Environment and Social Impact Assessment Report (ESIA) Addendum – Change in Design (CID) of Bhola 225MW Combined Cycle Power Project

28 January 2020

Project No.: 0518816

Figure 1.2 Site Layout Plan (Final Plan)

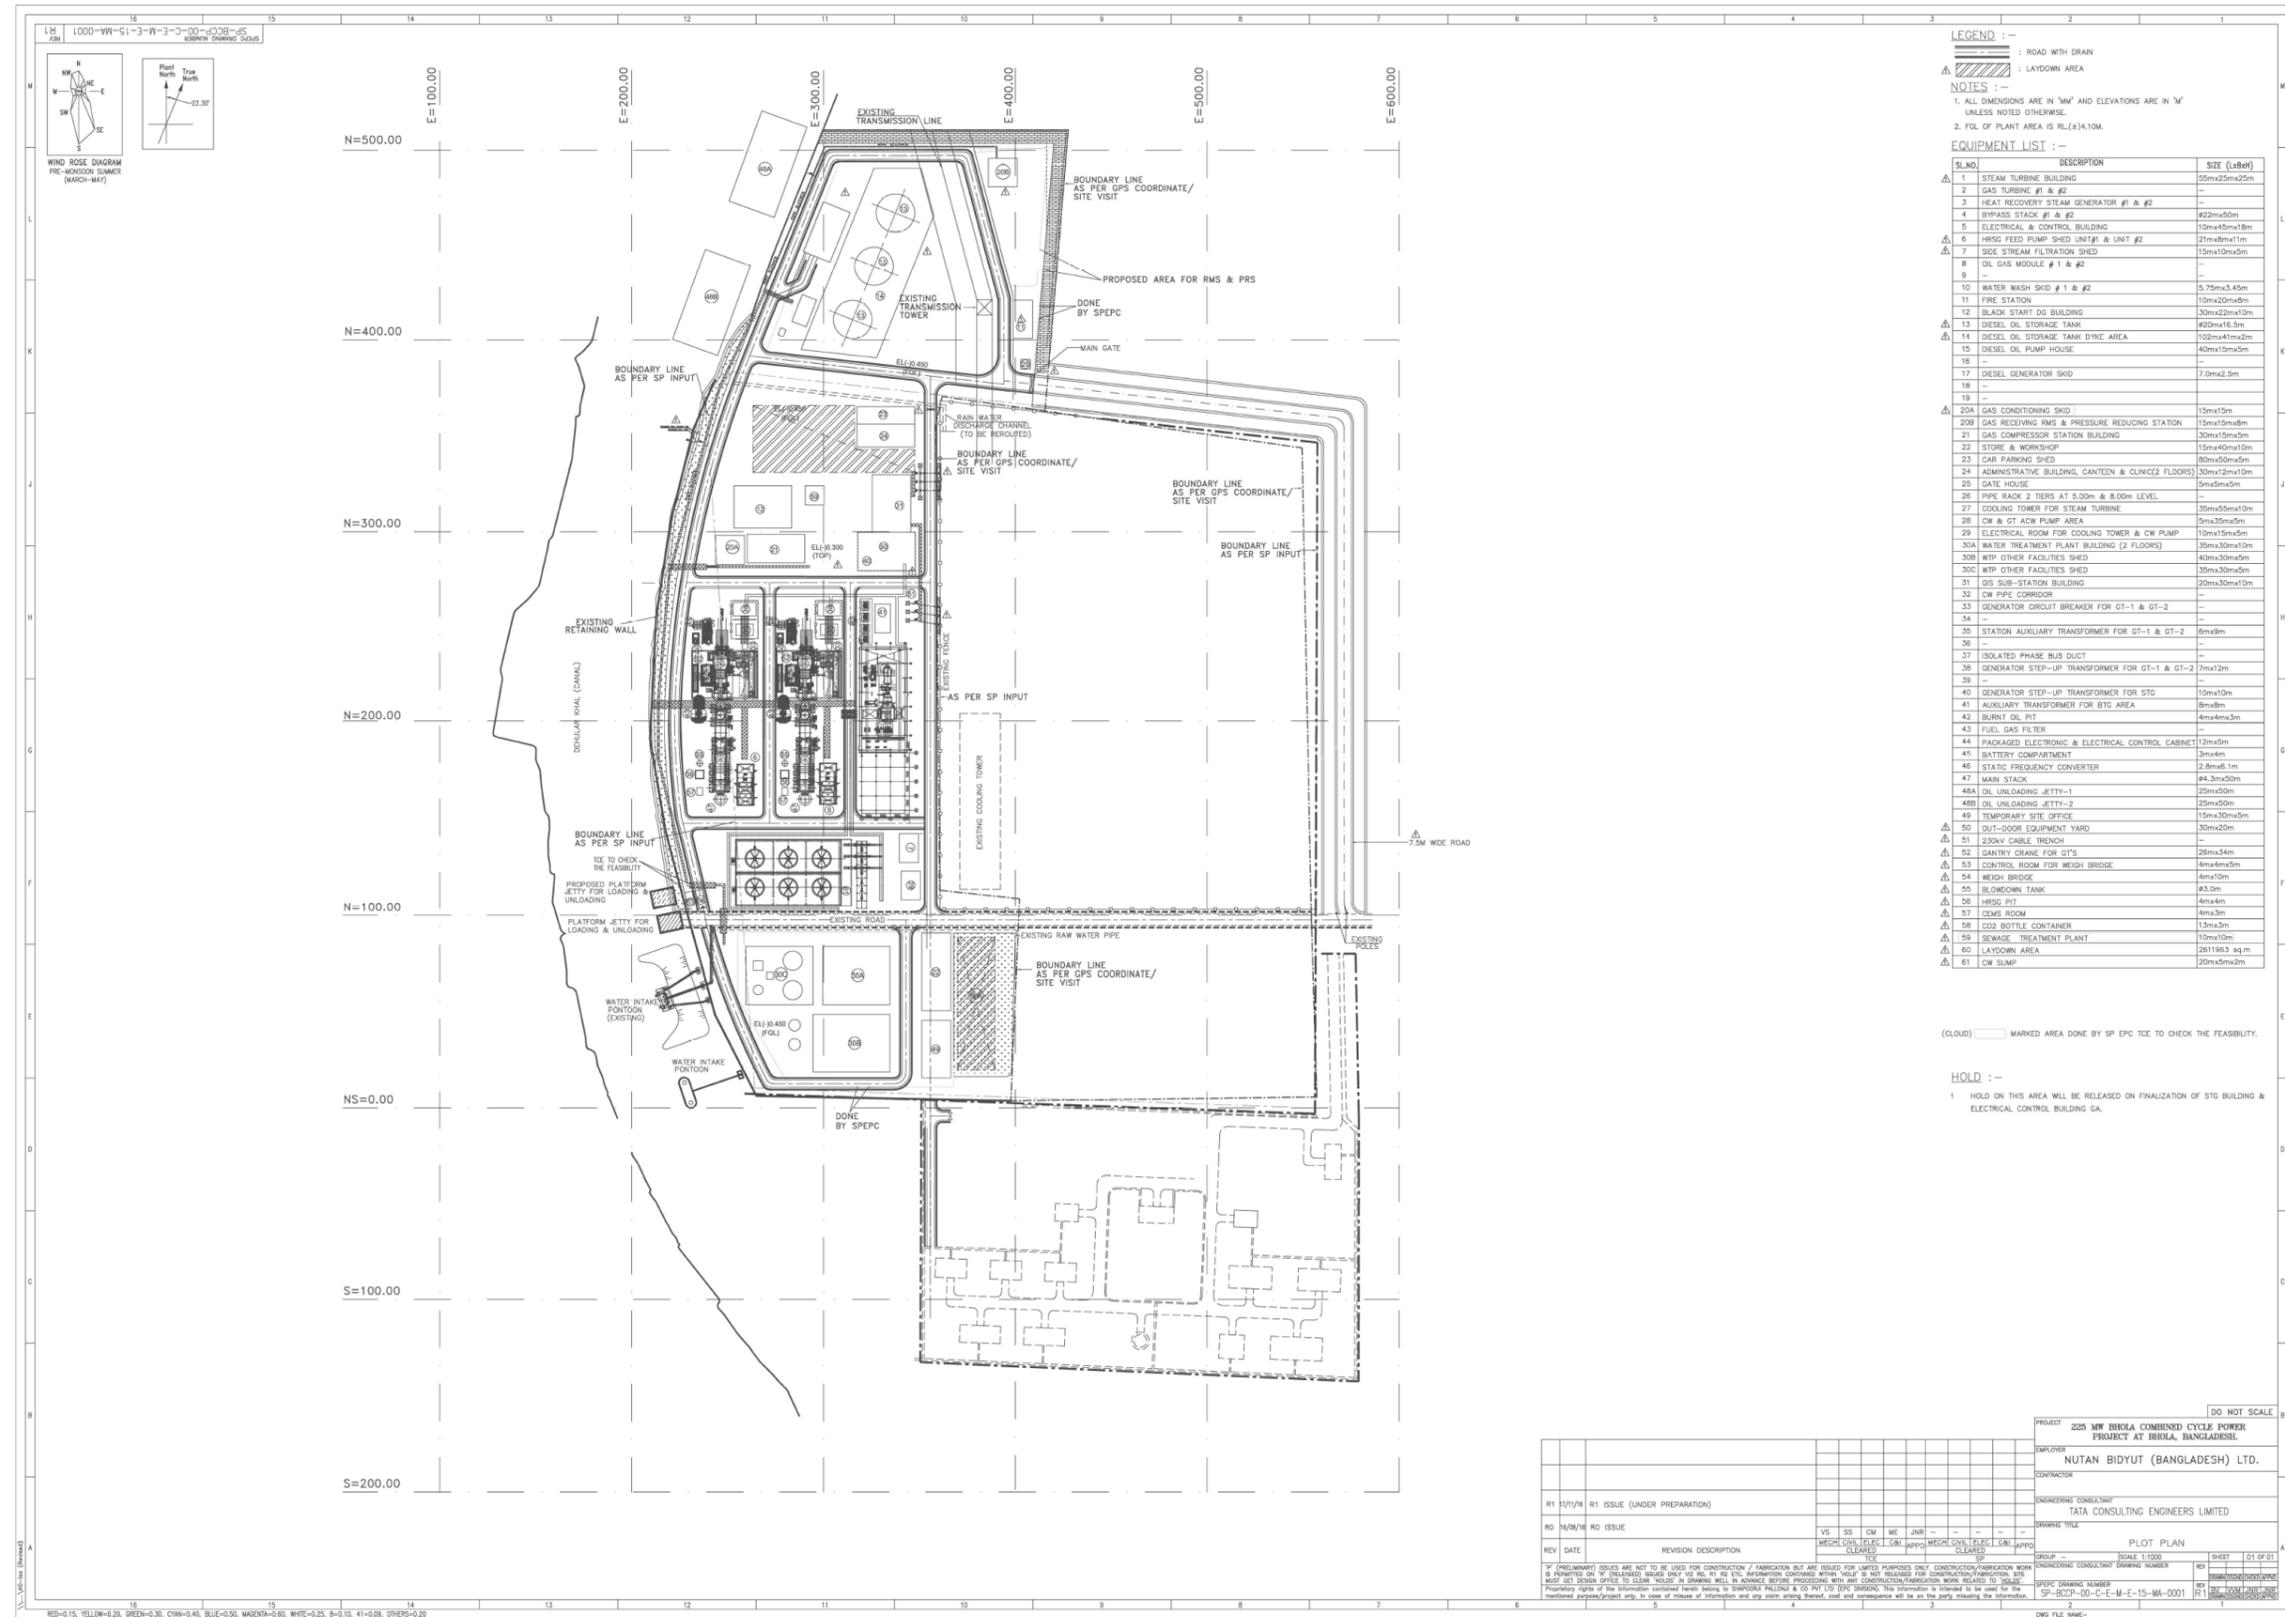
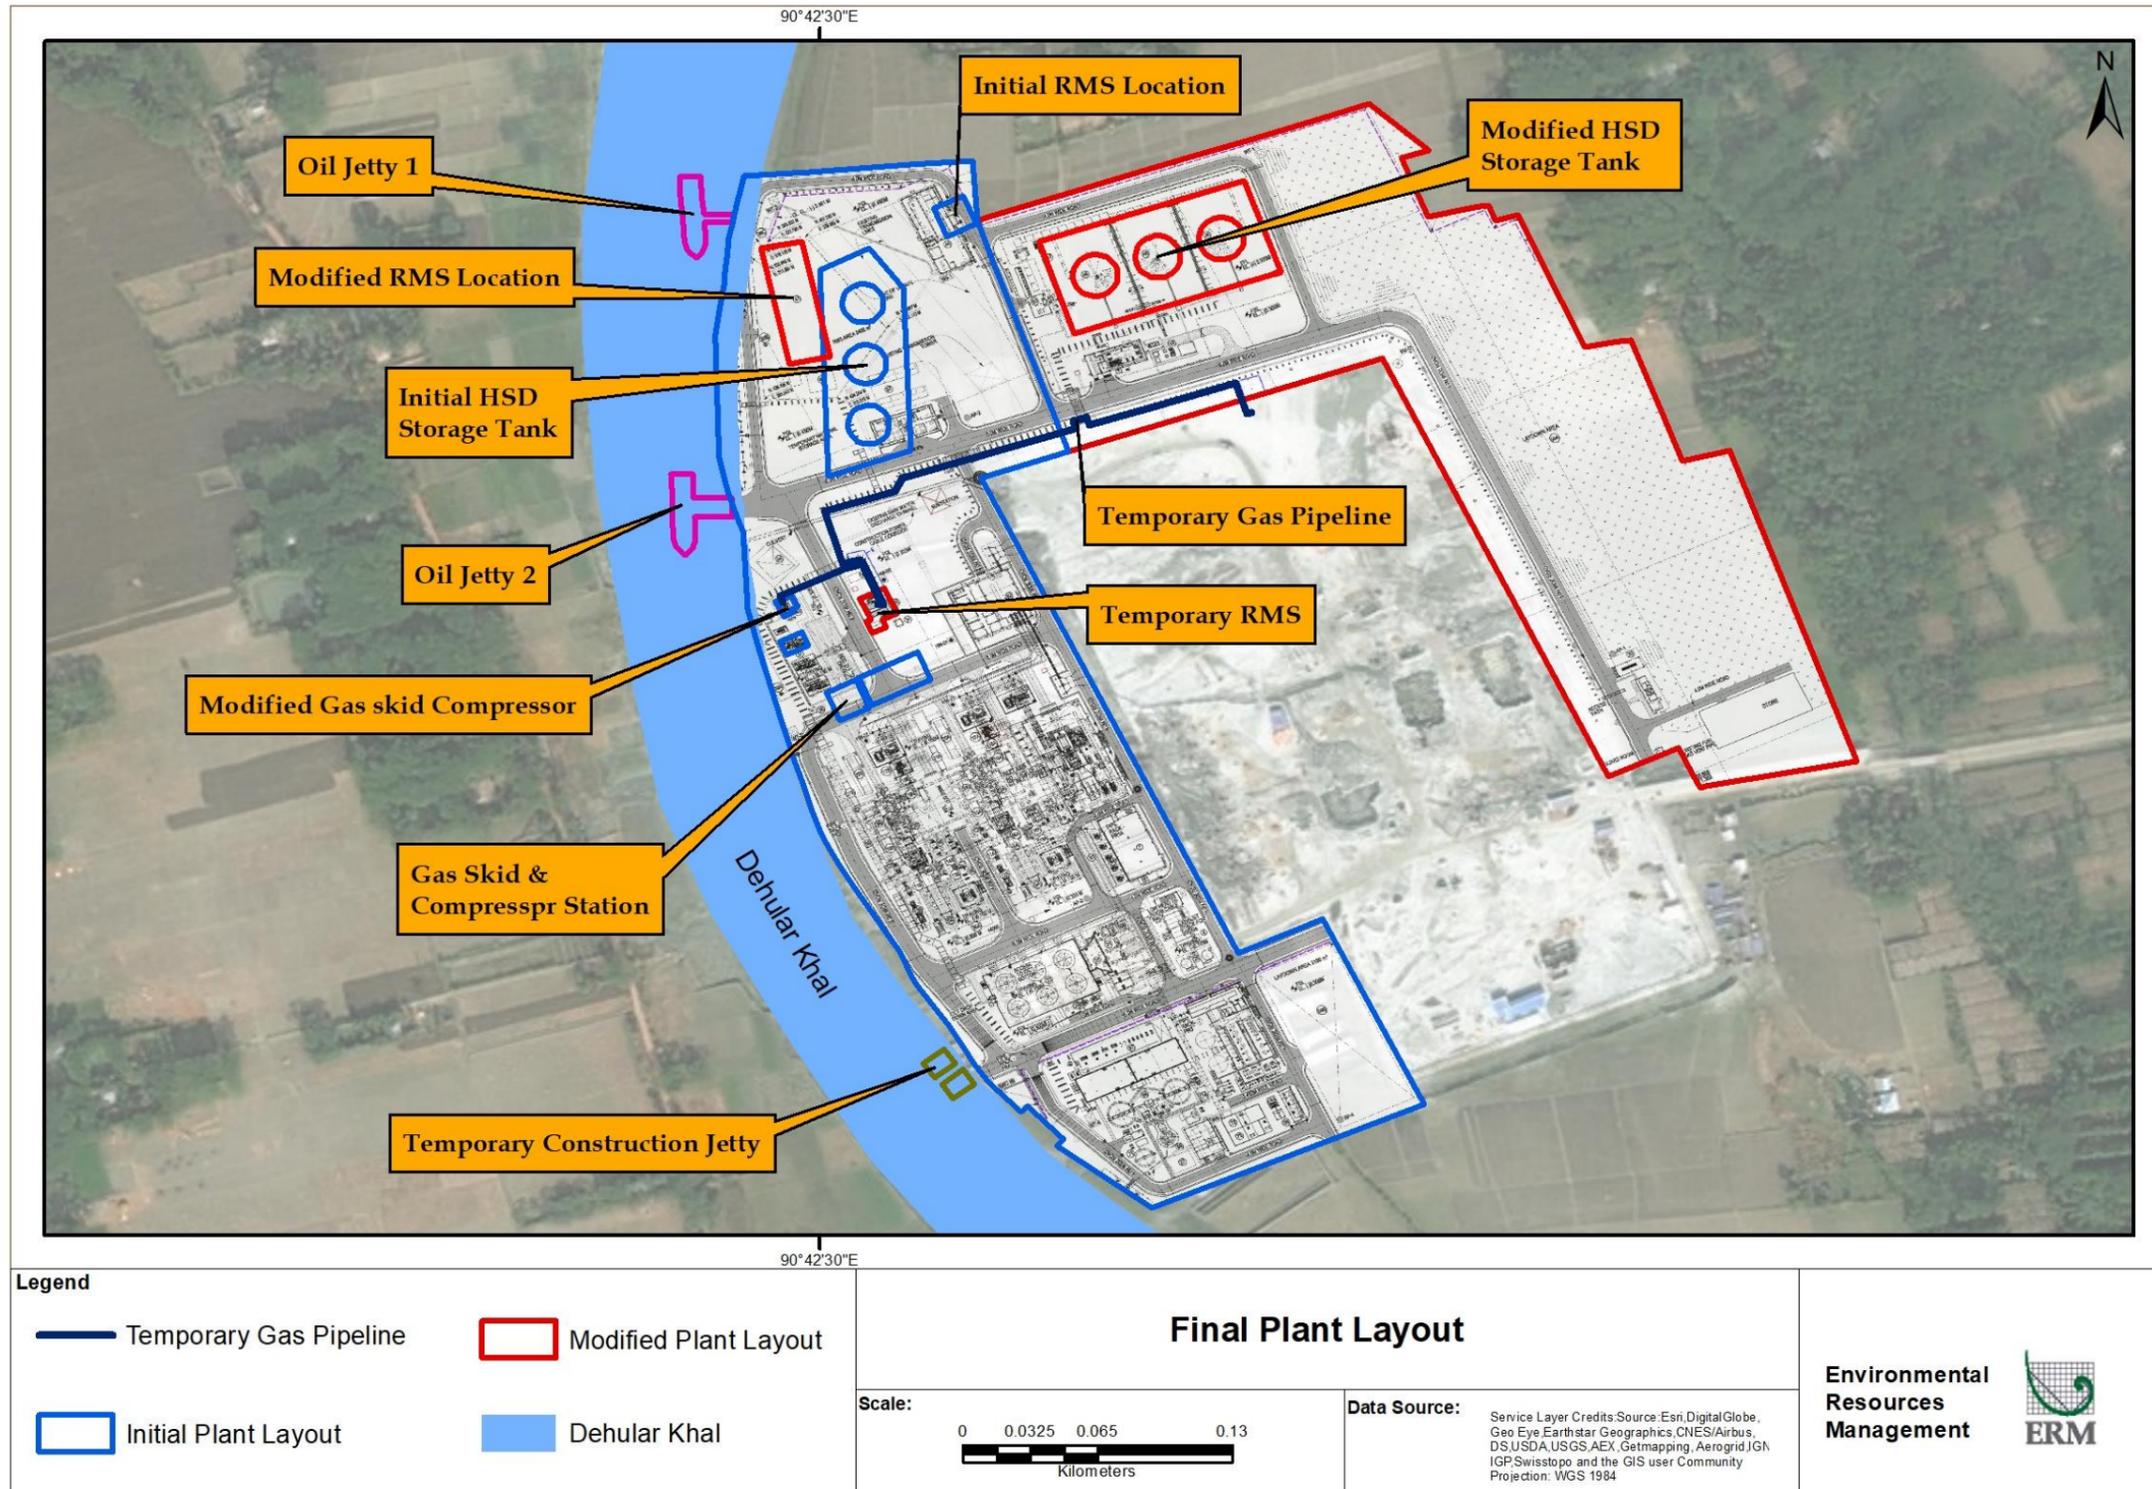
As per original site layout plan, HSD storage facility was located in Main plant Area (demarcated as main power plant site). In the revised site layout, HSD storage facility has been shifted to additional land procured for the project. However, storage capacity will remain same. The risk assessment and potential impact zone need to be re-assessed for shifting of HSD storage facility.

In the original plot plan the location of HSD storage facility was on the north-eastern side of the proposed plant. In the initial Plot Plan, Fuel storage area was proposed and utilized the space optimally. However while carrying out the detailed Engineering activity, some of the HSD dyke area was falling under the overhead transmission lines safe distance zone. In view of this and also to accommodate Fuel Oil pump house, foam pump house and oil water separator, are relocated to new location.

As per modified plan the HSD storage tanks will be shifted in the additional procured land; i.e. towards, eastern side. The modified storage location has been presented in **Figure 1.3**. The oil unloading jetty will remain same as proposed in original plan.

Figure 1.5 Temporary Gasline and RMS

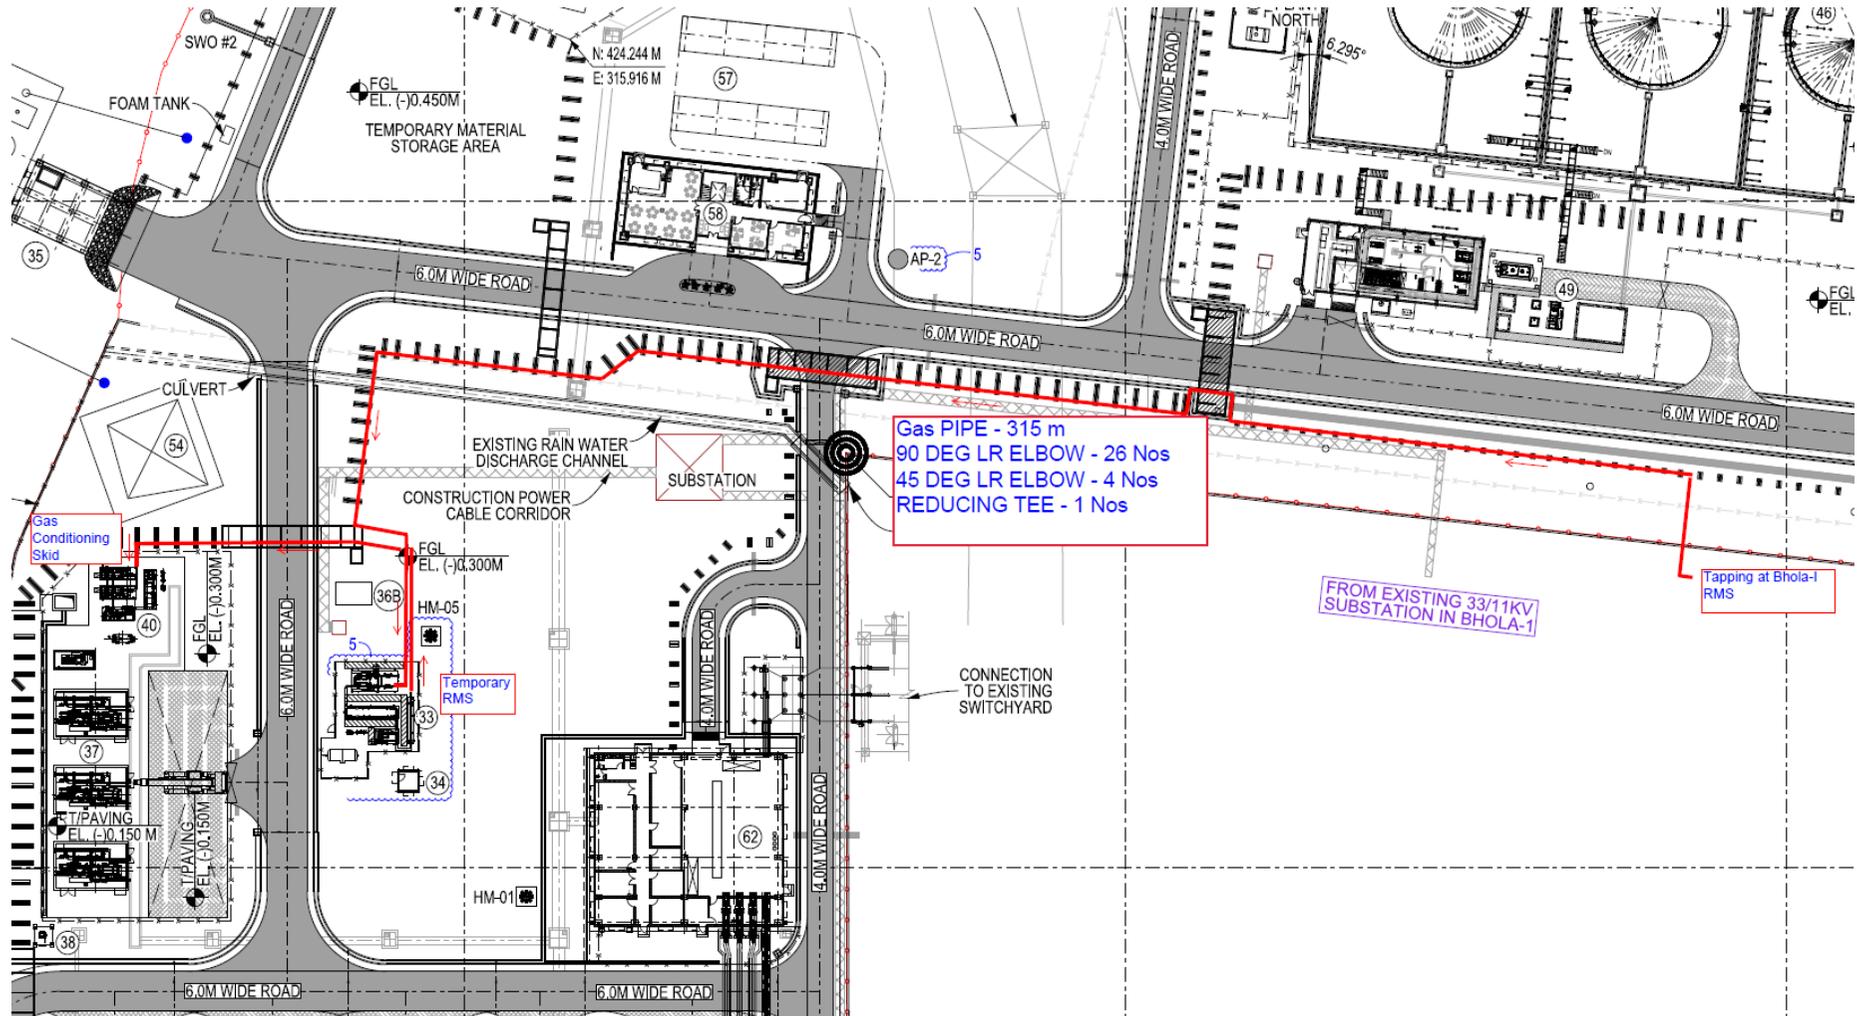
the proposed plant at North-East corner. NBBL has reported that, laying of gas pipeline and installation of permanent RMS will take approximately one years (I.e. end 2020). An interim arrangement will be made for supply of gas from Bhola I power plant. Approximately 315 m pipeline will be constructed from Bhola I RMS to NBBL temporary RMS. The temporary RMS system has been presented in **Figure 1.5**.
